## Product Change Notice (PCN)

**PCN Number: PCN-0451100R-01**

Product(s) Affected: SJD1-3201-54

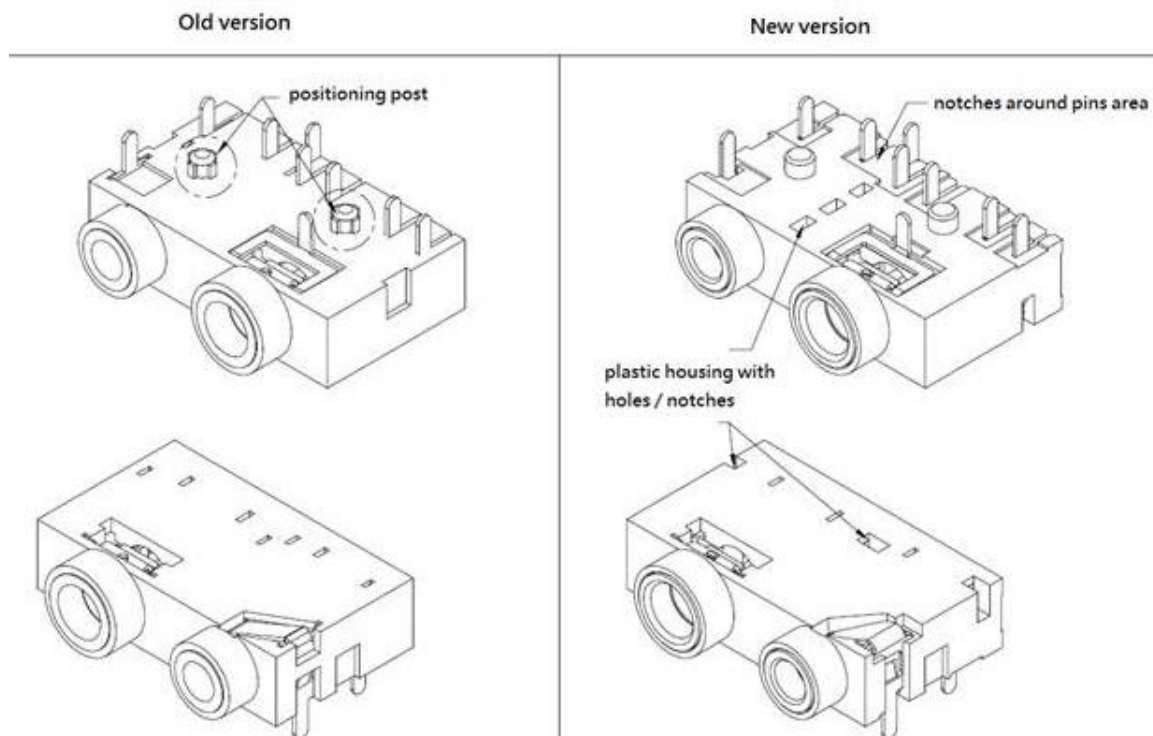
Description of Change: new tooling mold causes slight different appearance:

Additional Information: No change to other product dimensions or specs
